Monitoring Year 1 Report
FINAL
Meadow Brook Stream Restoration Project
Yadkin County, North Carolina
Yadkin River Basin, Hydrologic Unit Code (HUC) 03040101

**RE: Response to Draft Task 6 – Year 1 Monitoring Report for the Meadow Brook Site
Yadkin River Basin – CU# 03040101 – Yadkin County, North Carolina
NCDMS Project # 100024, Contract # 007184**

Monitoring Year 1 Report - FINAL

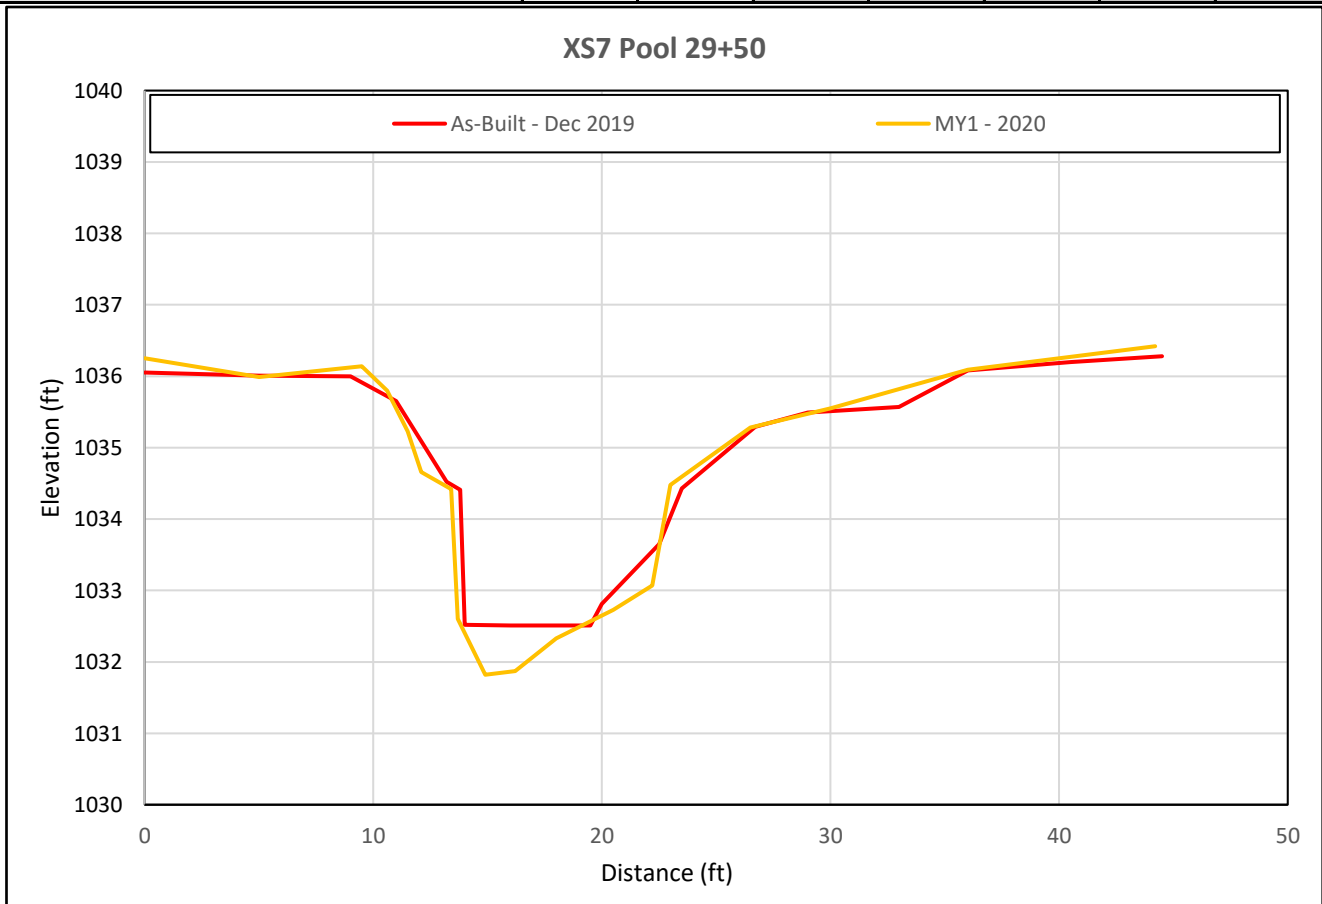
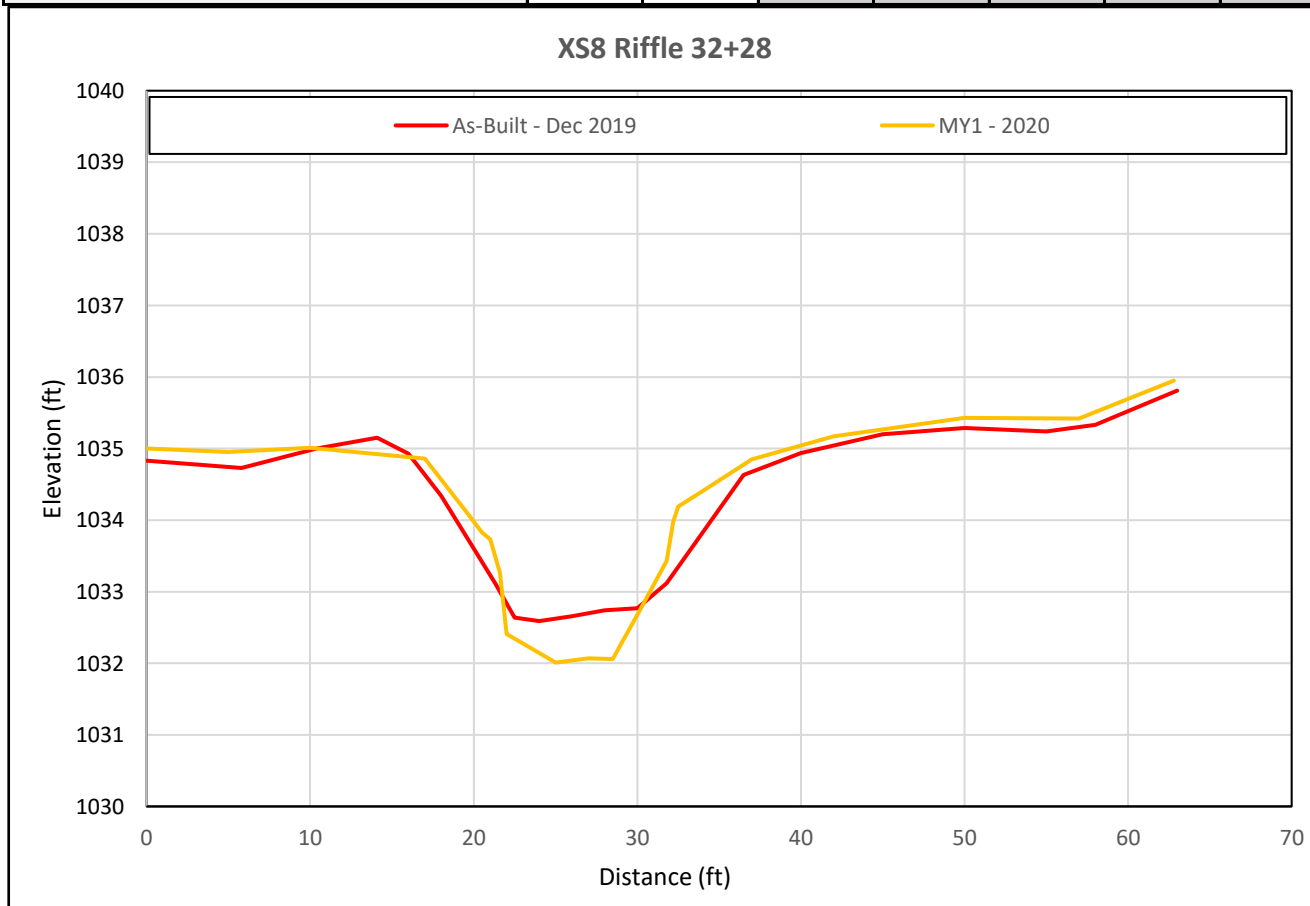
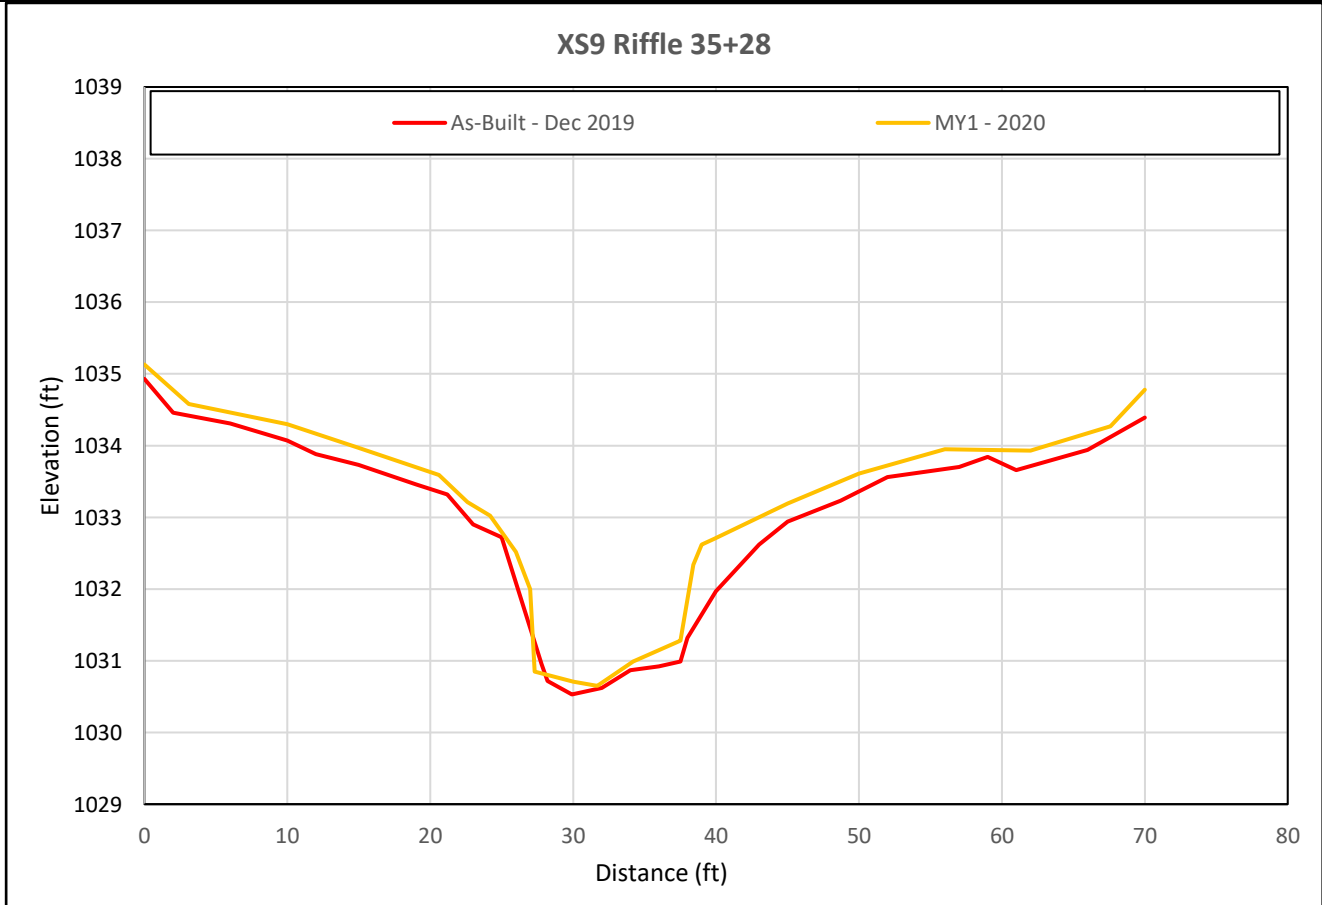
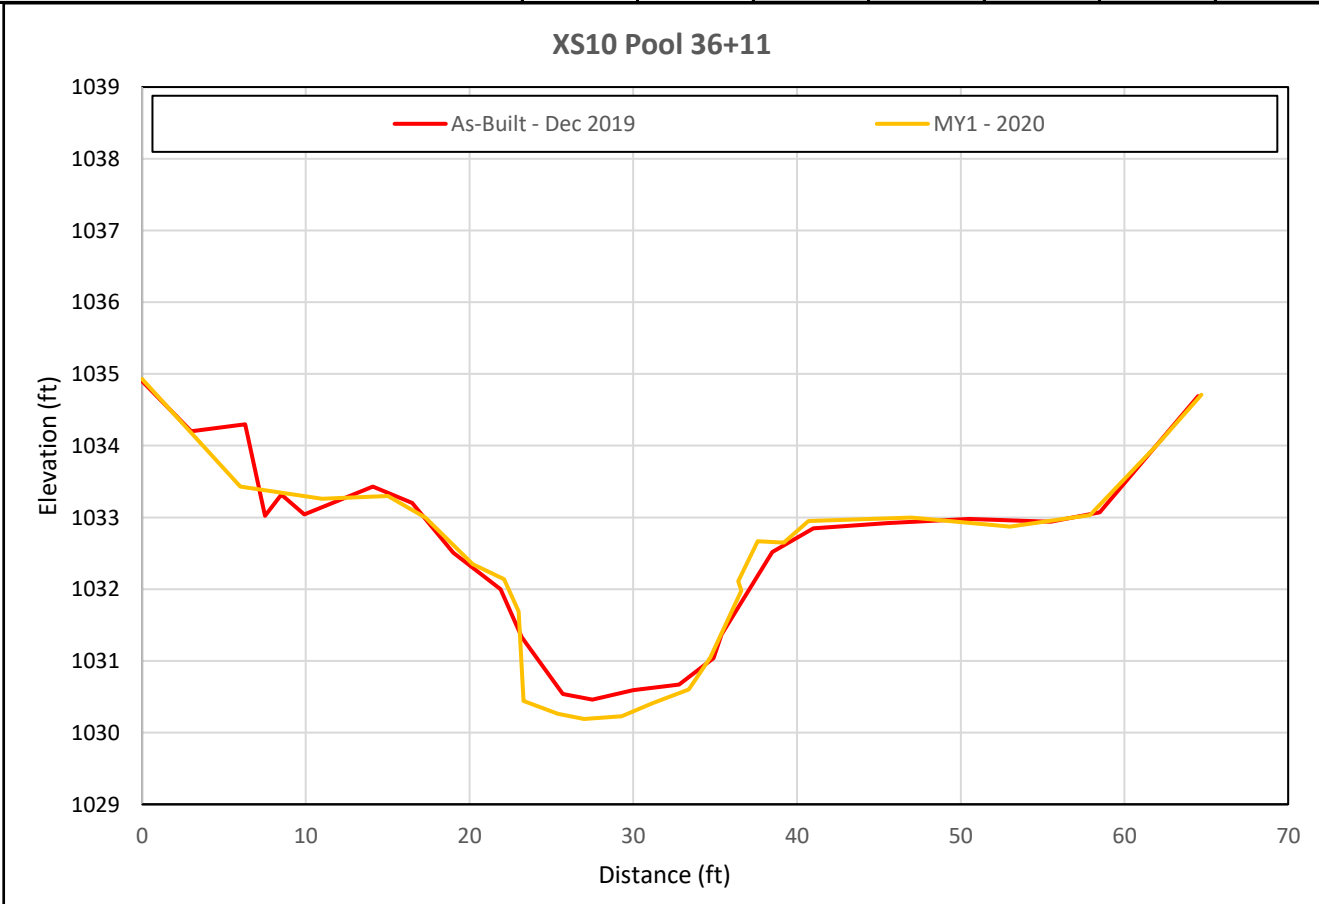
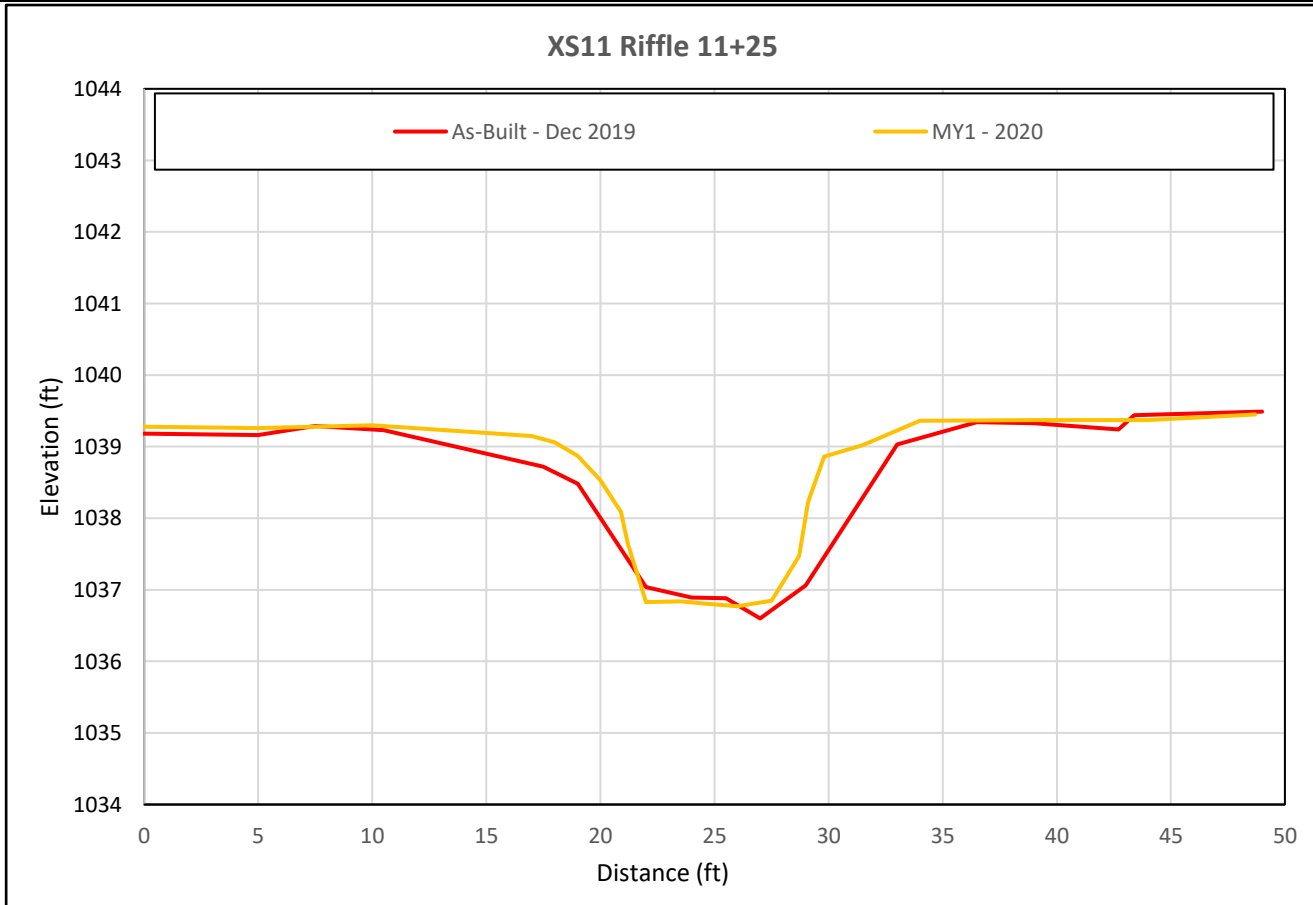
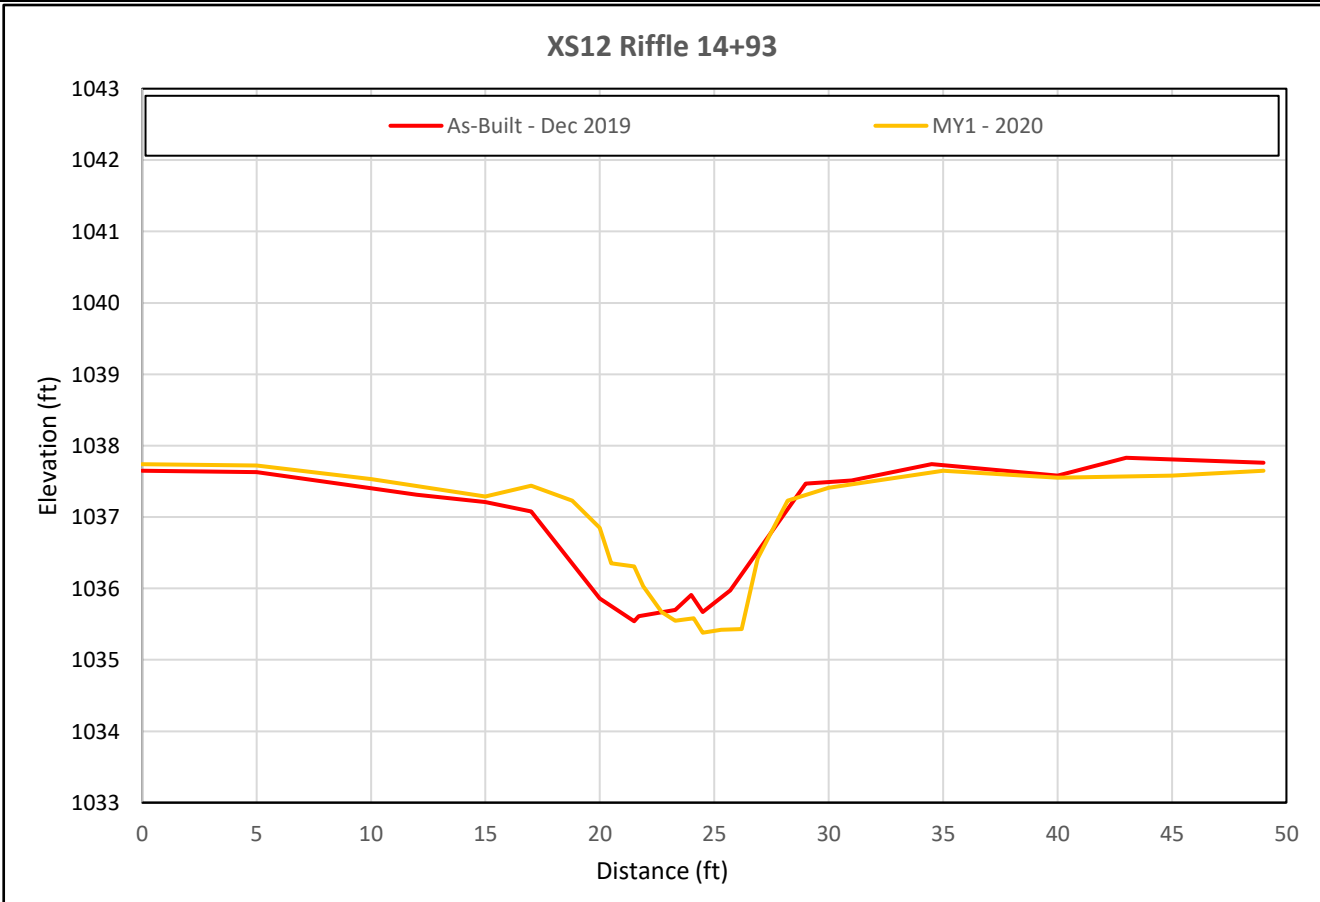
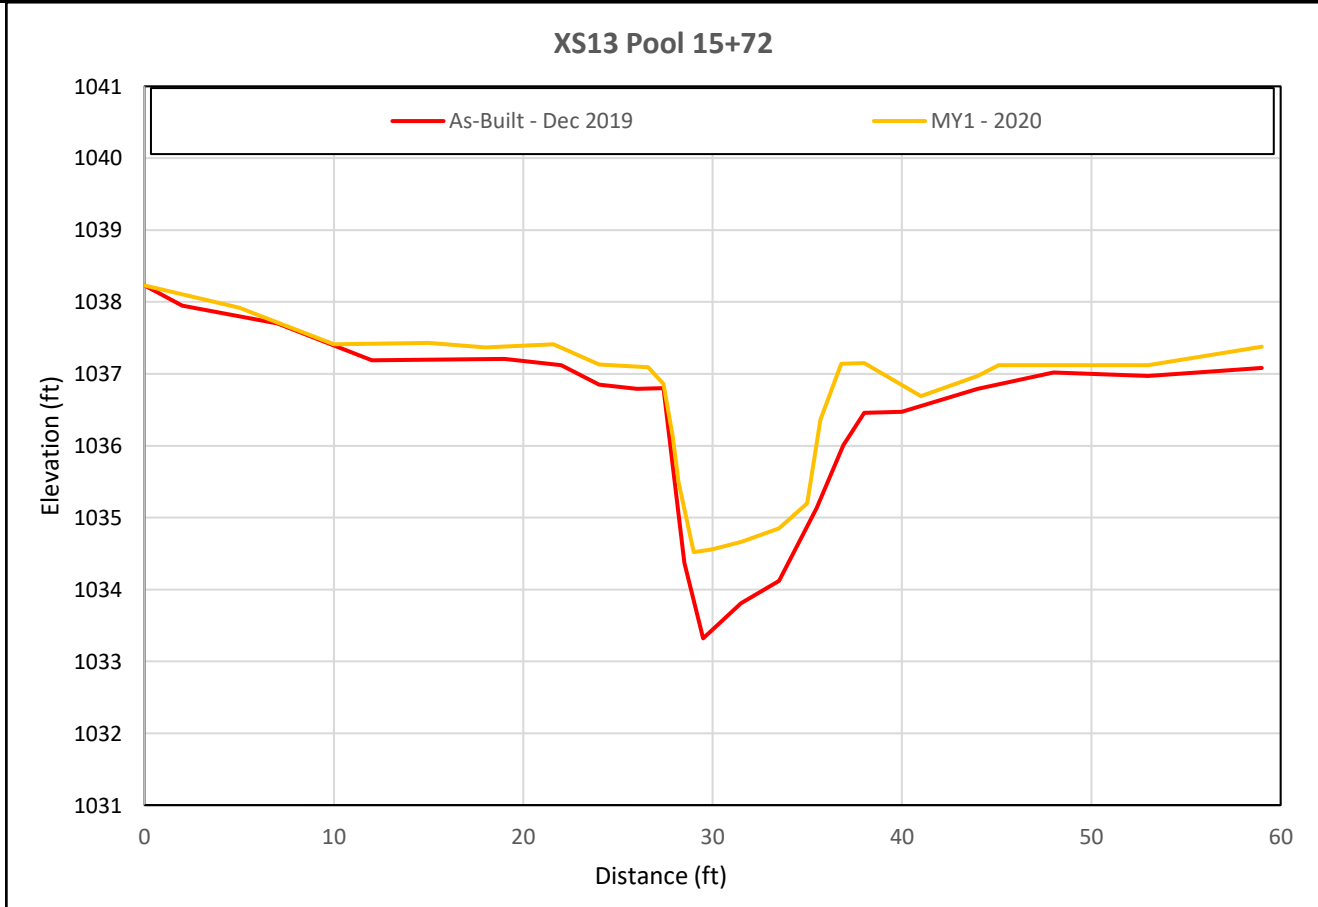
- *Cross section graphs 7 – 13 are indicated as "Baseline". Please correct the titles.*
 - **The cross-section graph titles have been corrected.**
